3GPP TSG RAN Meeting #28 RP-050270

Title CRs to 34.121 for approval Batch 2

Source 3GPP TSG RAN WG5 (Testing)

Figure 5.7A.1: Transmit power template during HS-DPCCH transmission

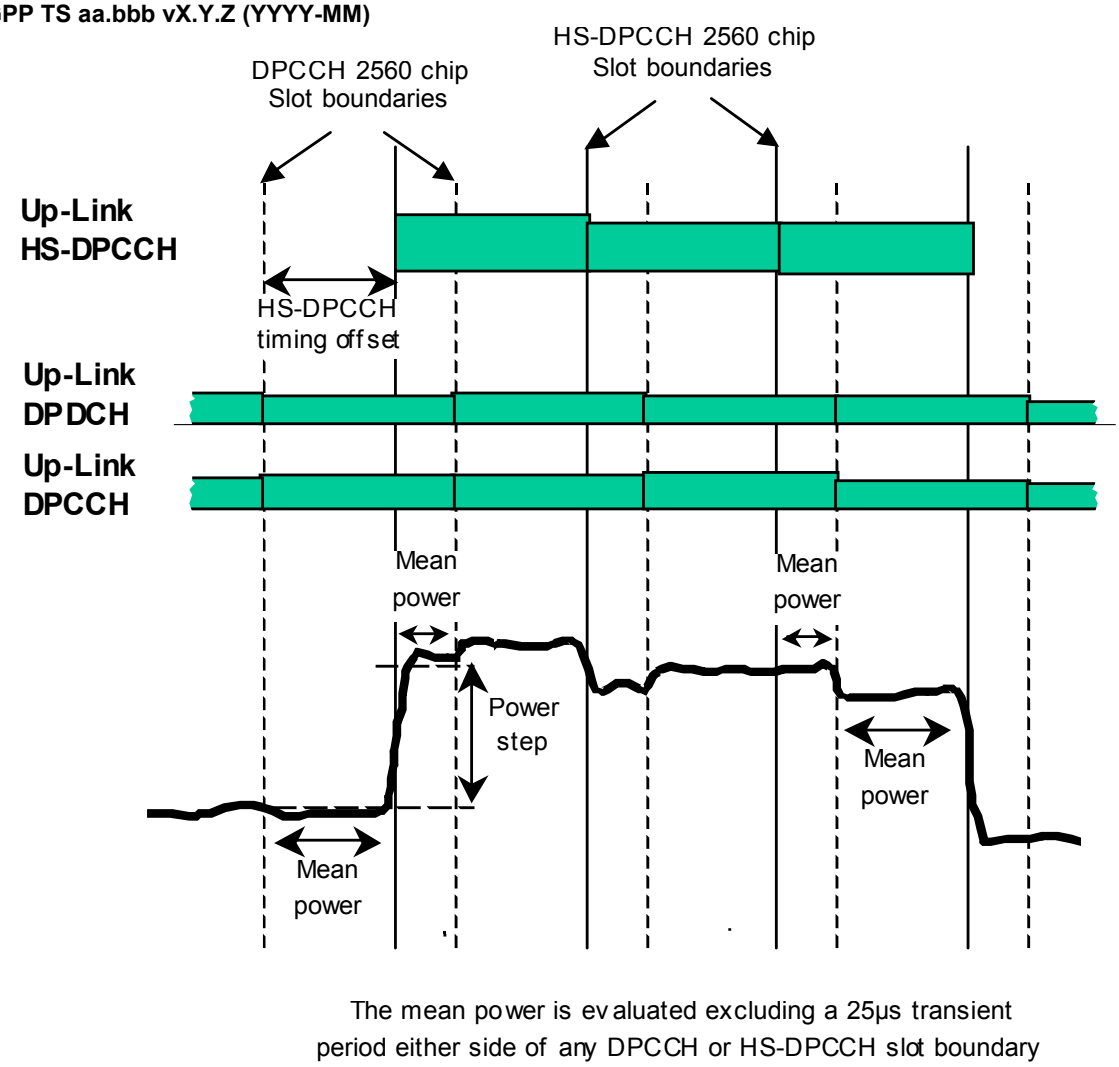
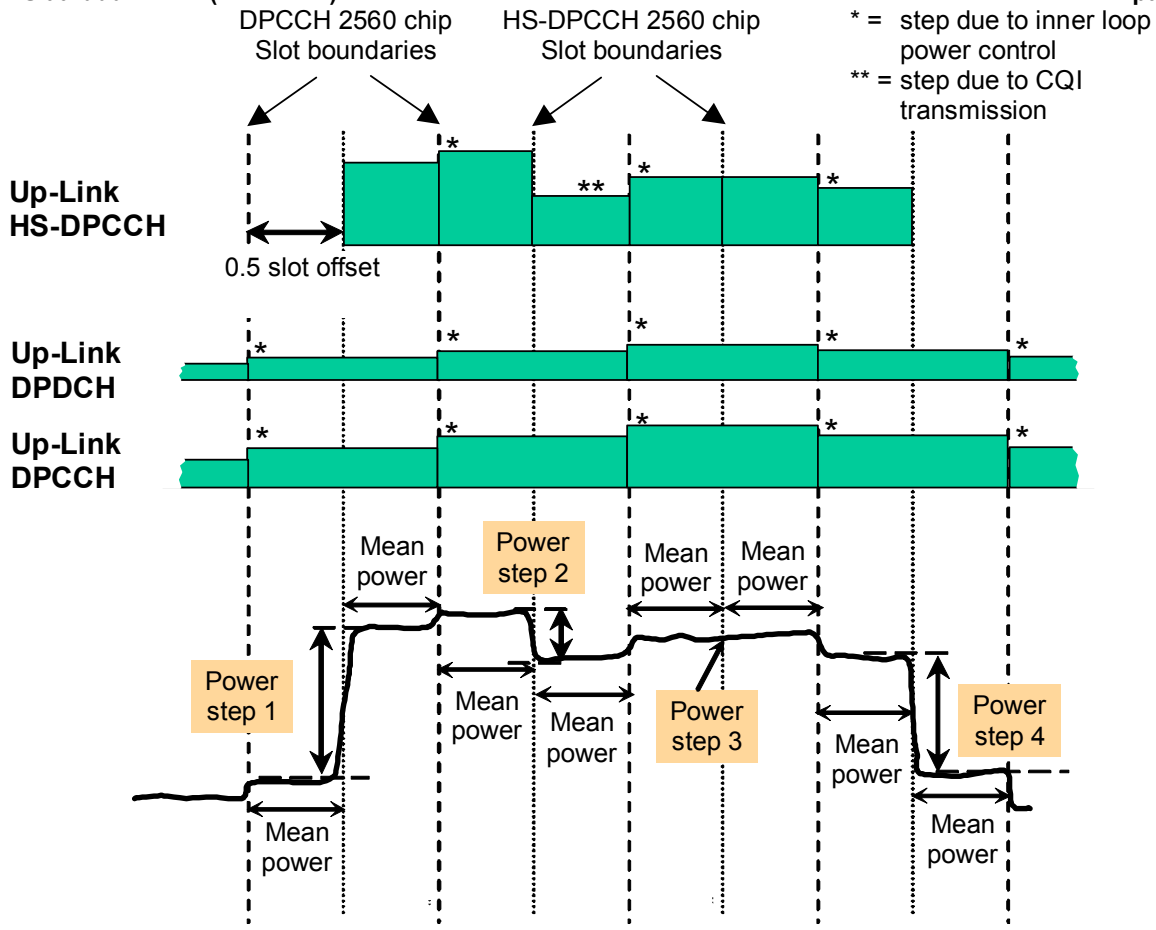
Reason for change:	⌘	There is no test case available to test the HS-DPCCH On/Off power steps and time mask during Ack/Nack or CQI transmission.
Summary of change:	⌘	Specified new test method and test requirements
Consequences if not approved:	⌘	TS 34.121 would remain incomplete for HSDPA testing and there would be a limited coverage for HS-DPCCH testing.

The transmit power levels versus time shall meet the mask specified in Figure 5.7A.1.

The transmit power levels and steps shall meet the time mask specified in Figure 5.7A.2.

The HS-DPCCH power step is the difference between the mean power measured either side of the indicated HS-DPCCH slot boundaries. The mean power is evaluated excluding a 25µs period either side of any expected power step.

Figure 5.5.1: Transmit ON/OFF template for PRACH preambles

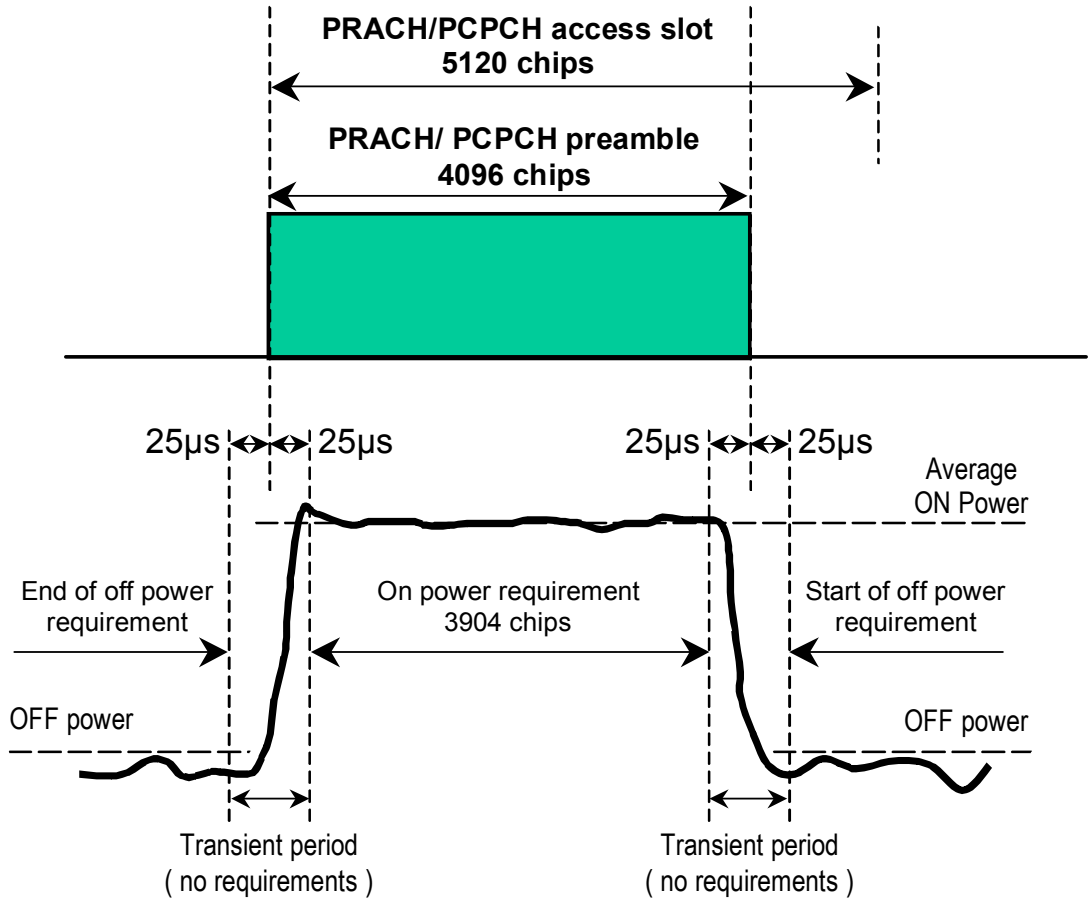
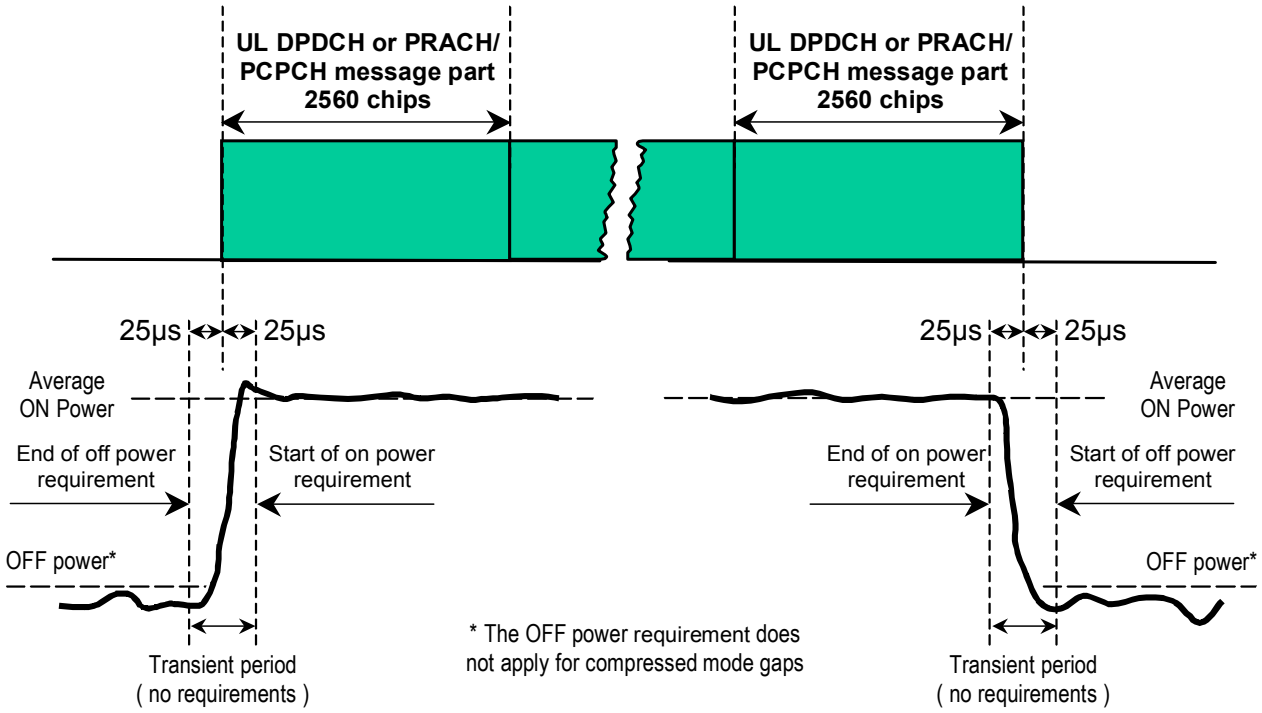
Reason for change: ⌘ Too low S-CCPCH power causes UE call set up problems in Test cases 5.4.1 (Rx-sensitivity level) and 5.5.2 since UE misses paging messages. In these tests TS 34.121 specifies that S-CCPCH_Ec/Ior power is -10.3 dB (see tables 5.4.1.3 and 5.5.2.3 and E.2.1). Since Ior is at -106.7 dBm the S-CCPCH power is at -117 dBm. Since the noise floor (taking into account UE Noise Figure) is about -99 dBm, the effective S-CCPCH_Ec/Io equals to -18 dB.

Summary of change: ⌘ S-CCPCH is increased by 5 dB from –117 dBm to –112 dBm in tests 5.4.1 and 5.5.2. Tables 5.4.1.3, 5.5.2.3 and E.2.2 have been modified accordingly. In order to keep the Îor unchanged the P-CCPCH power is decreased by 5 dB. Keeping Îor unchanged is important for testing RX upper dynamic end in Table 5.4.1.3.
